**RE: 145 Tait Avenue**

I reviewed the drawings, and evaluated the site context. My comments and recommendations are as follows:

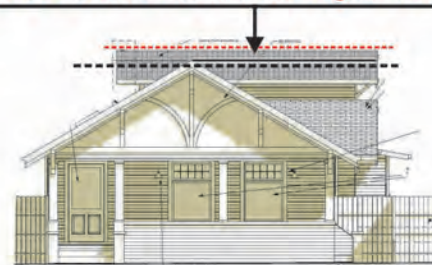
**Second floor addition was treated as a dormer with a ridge line lower than the main roof which is consistent with the original architectural style of the house**

However the dormer's flattened roof slope compared to the original home's traditional steeper slopes would today be in conflict with the town's Residential Design Guidelines 3.5.1 and 4.8.8.

While the roof slope of the current second floor dormer is not consistent with the current town Residential Design Guidelines, it was previously approved and is modest in appearance. I would not recommend any changes to the existing roof slopes.

**SOUTH/TAIT AVE ELEVATION**

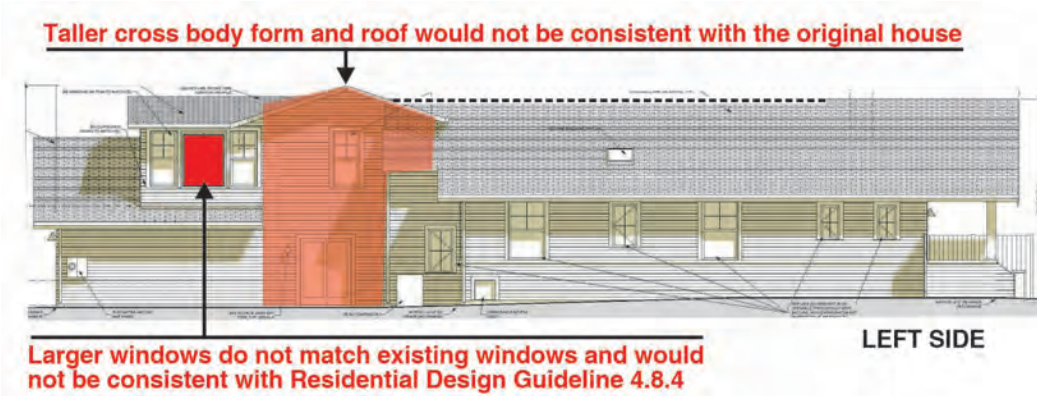
1. The proposed increase in the roof ridge height of the second story dormer element and its extension across the main roof ridge would be counter to blending the addition into the original structure as a subordinate mass, and it would also change the wall and roof forms on the left side elevation to one very much out of character with the architectural style and small scale of the home.

**Taller cross body form and roof would not be consistent with the original house**

**Taller cross body form and roof would not be consistent with the original house**

1. Maintain the subordinate character of the second floor additions by maintaining the existing dormer roof ridge height and eliminate its extension to the opposite side of the structure.

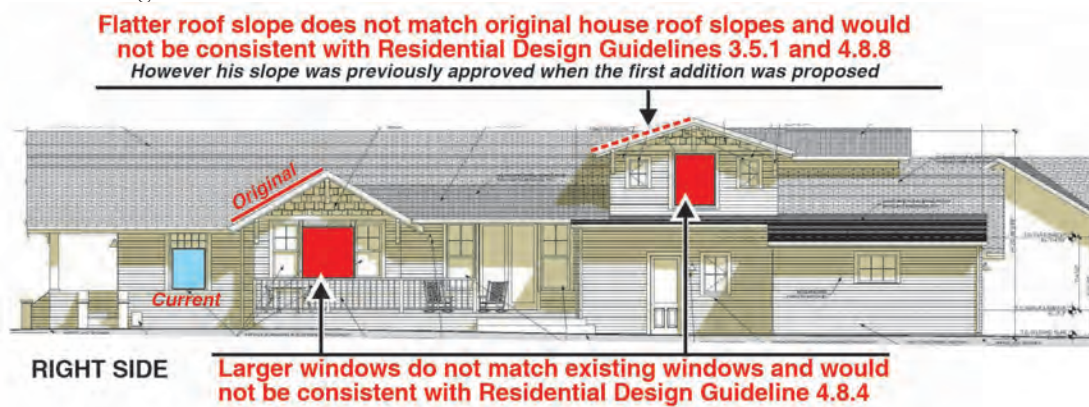
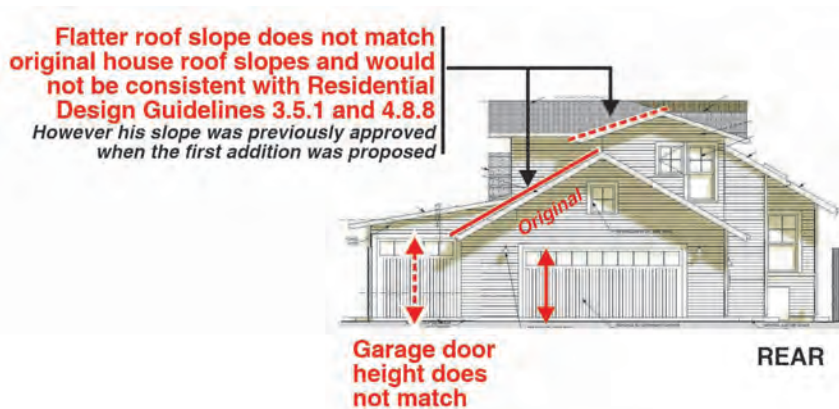
2. A few windows are proposed to increase in size over those currently on the house facades which would not be consistent with Residential Design Guideline 4.8.4.

- All elements of new windows should be identical in size, shape, proportion, and dimensions as the original windows of the building, or consistent with traditional sizes, proportions and dimensions of buildings of the same architectural style, design and era.

2. Replace the large new windows which are inconsistent with the existing windows on the house with ones that match the size and proportions of existing windows.

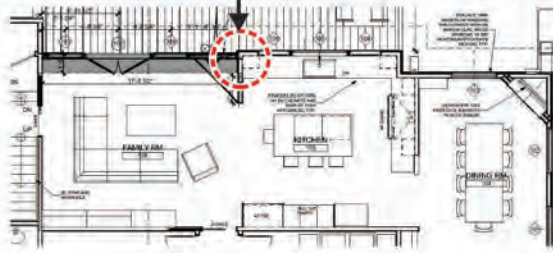
4. A question has been raised about the appropriateness of the proposed windows.
5. The Family Room wall has been pushed outward to provide more floor area in that room. However, this would result in a visual reduction of the bay window projection which would not be consistent with preserving the integrity of the original design.

**Small setback at new wall reduces bay projection and would not be consistent with preserving the original design of the home**

4. Per Residential Design Guideline 4.8.4- Windows should be constructed of real glass, and window frames should be constructed of real wood - not vinyl, metal or plastic. Wood sashes may be vinyl or metal if the window frame and dressing is designed consistent with the historic context of the building. The proposed Marvin Ultimate wood clad windows are appropriate for the proposed project.
5. Per Residential Design Guideline 4.8.5 Bay Windows. Provide a minimum one-foot setback of the Family Room wall adjacent to the existing bay window.

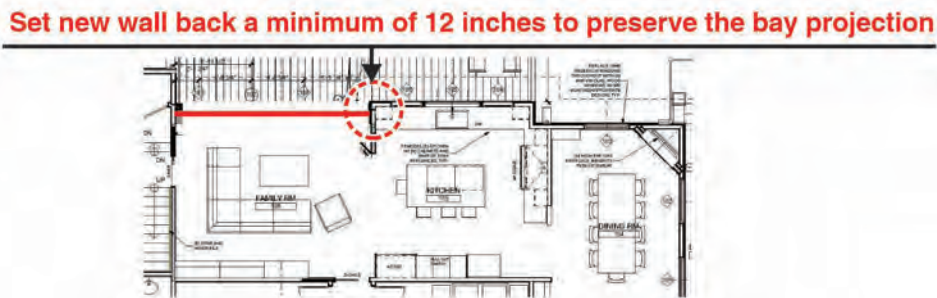
3. The head height of the door on the garage addition is higher than the existing garage which seems at odds with the simplicity of the existing structure.

3. Match the garage addition's door height to that of the existing garage.
